REGIONAL REVIEW NOTICE

ARC REVIEW CODE: R1303041

Name of Proposal: CSX Intermodal Facility – Track Expansion

SUBJECT: **Transportation Division Review of DRI # 2326**
Project: CSX Intermodal Facility - Fairburn
County: Fulton
Location: 6700 McLarin Road; Fairburn, GA
Analysis:
Expedited ☒
Non-Expedited ☐

[CSX.] CSX INTERMODAL TERMINALS, INC. TERMINAL DEVELOPMENT GROUP JACKSONVILLE, FLORIDA			
REVISIONS		SUPPORT TRACK EXPANSION	
		FAIRBURN TERMINAL FULTON COUNTY, GA	
DATE:	9/28/2012	DRAWING TYPE:	DRAWING NUMBER:
DRAWN:	JDC	PROJECT NUMBER:	12-029
CHECKED:	-----		SHEET 1 OF 2

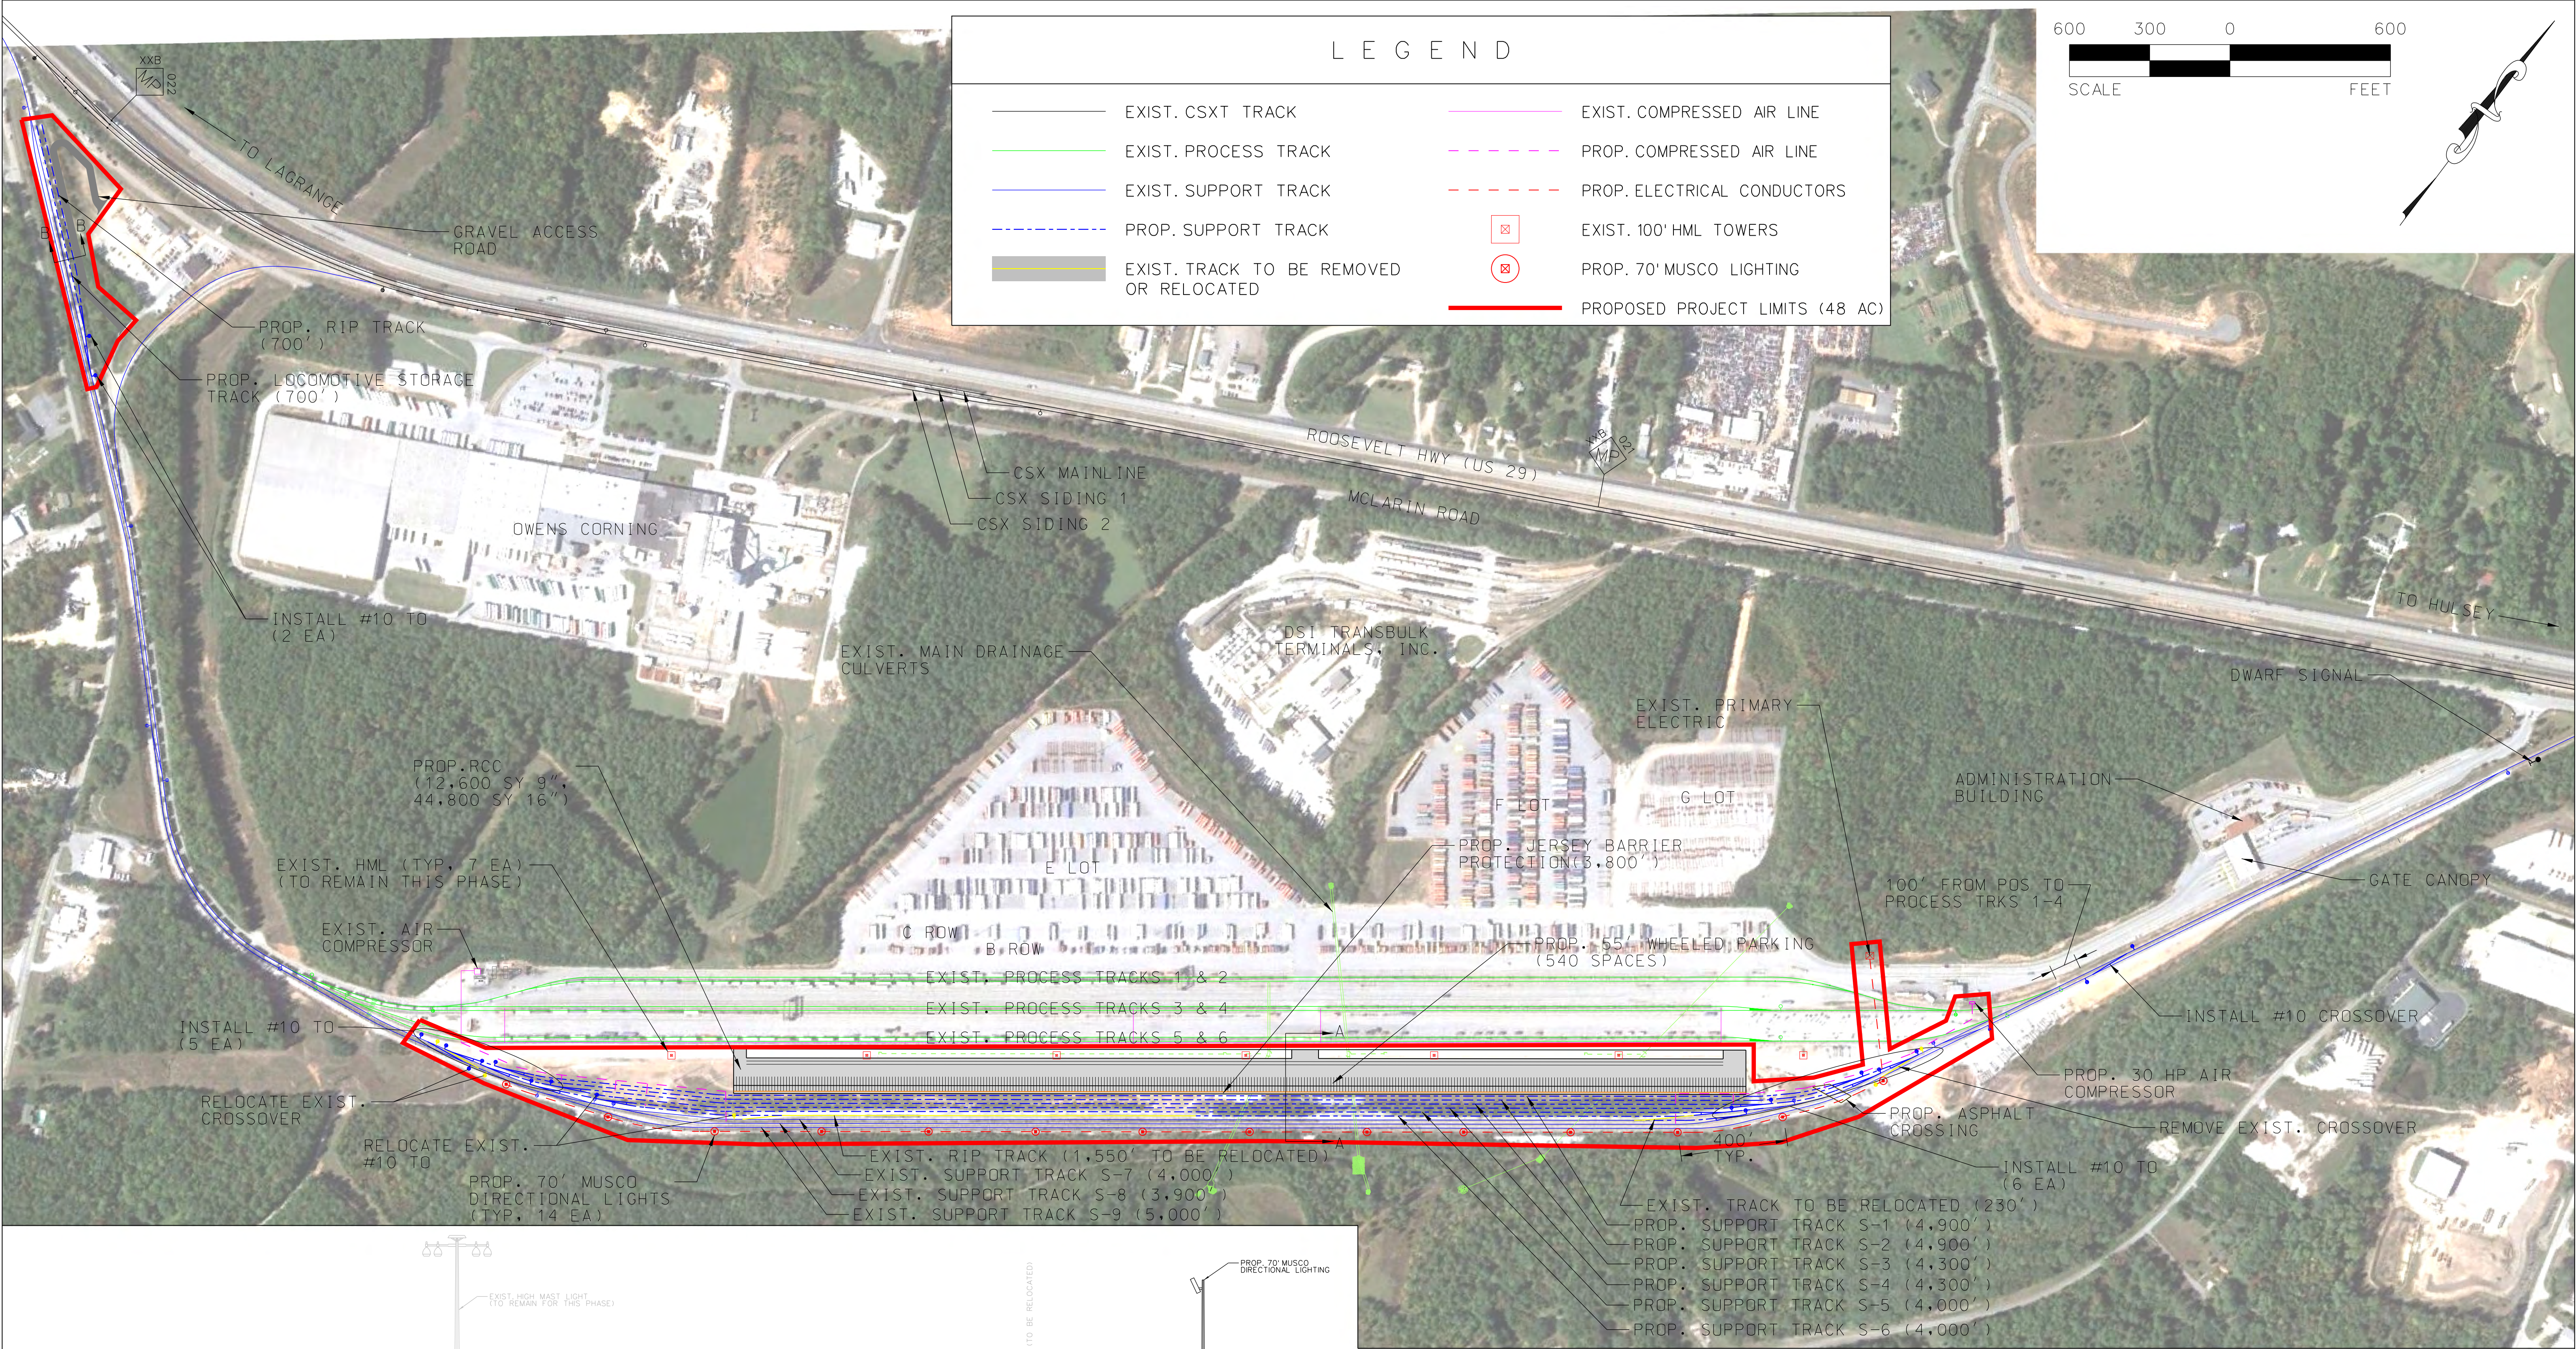
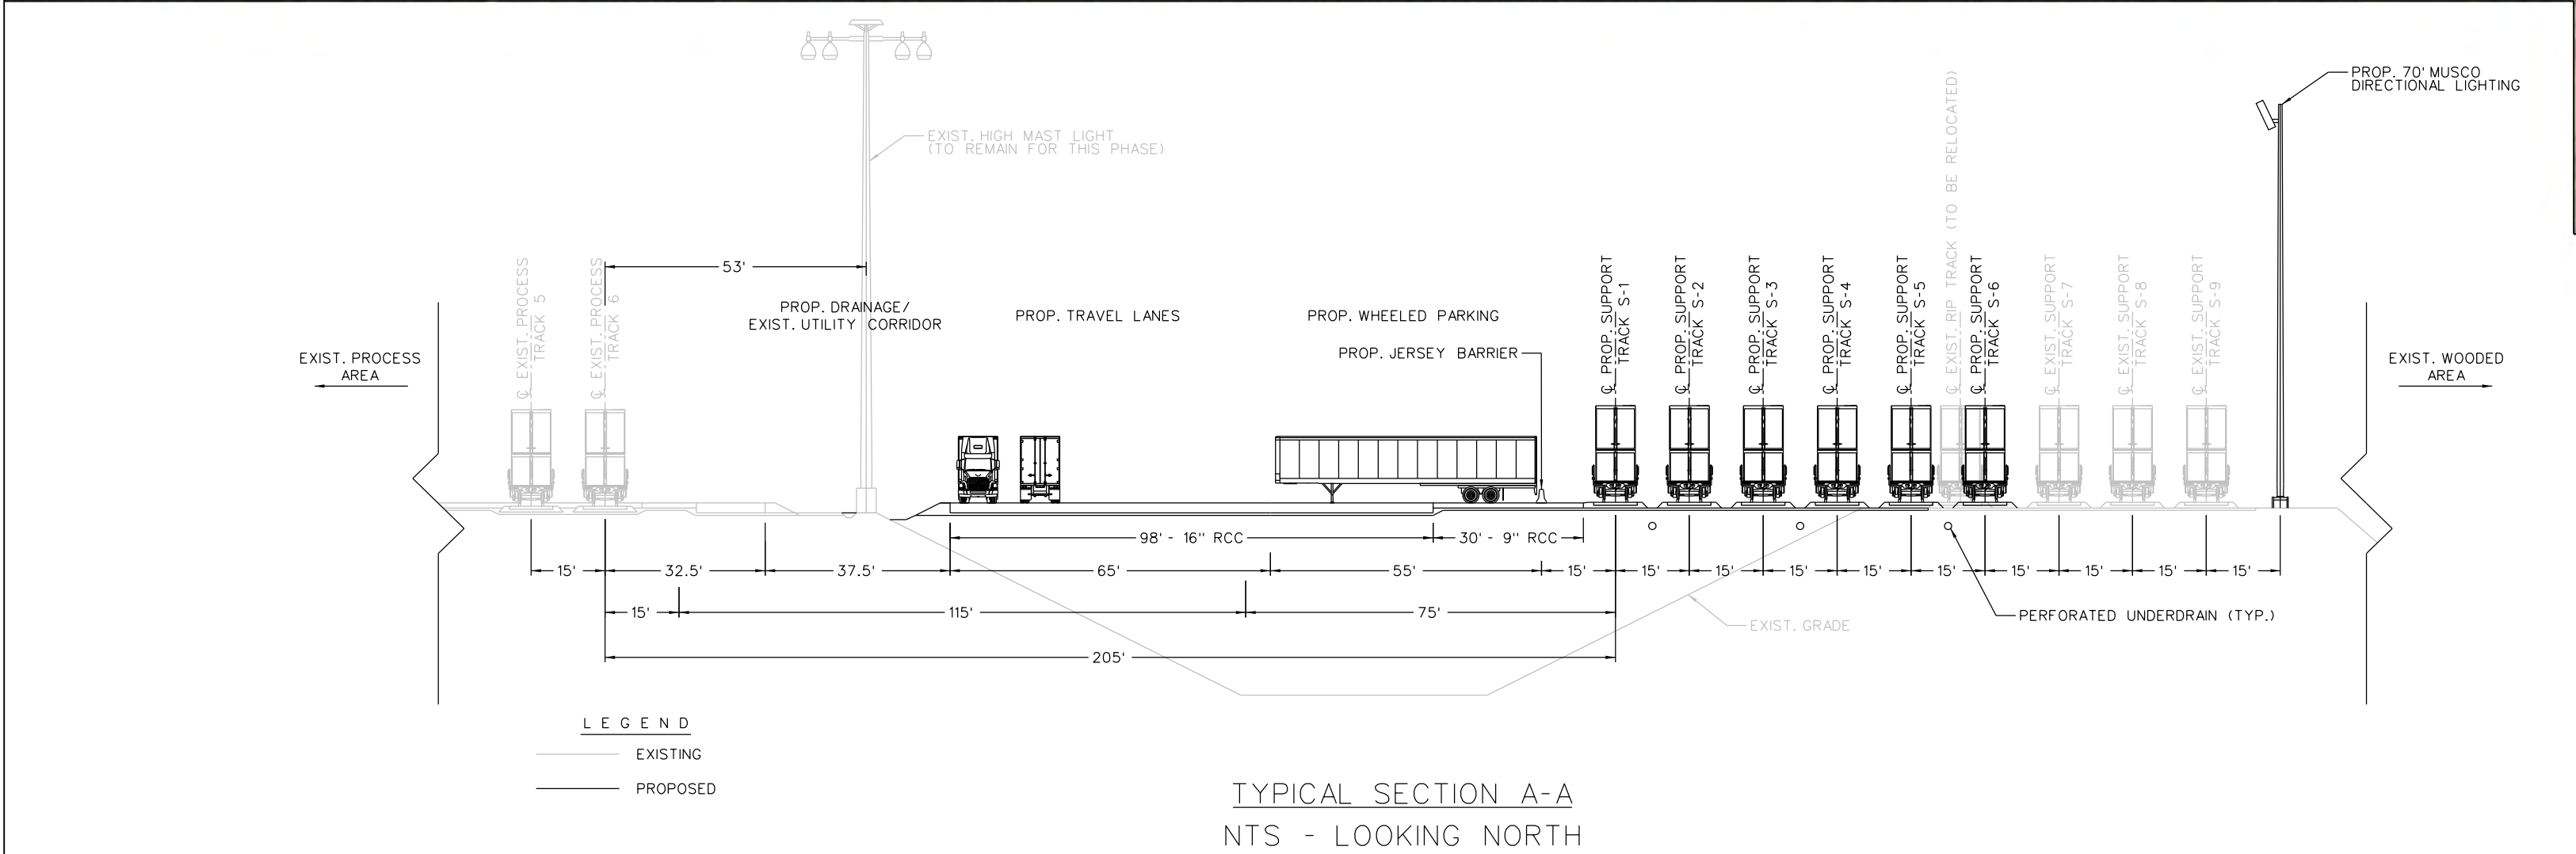
The USGS coverage for the project area shows two blue line streams on the project property: the headwaters of Line Creek and an unnamed tributary of Line Creek. The existing rail facility crosses both streams, which have been piped under the existing facility. Based on the submitted plans, the proposed expansion will be built between two existing rail areas where the streams are already piped. No increase in piping is indicated.

The City will need to determine if the proposal meets the Water Supply Watershed Buffer Criteria. It will also need to be determined if the proposed project requires variances under the City Stream Buffer Ordinance and the State Sediment and Erosion Control Buffer requirements.
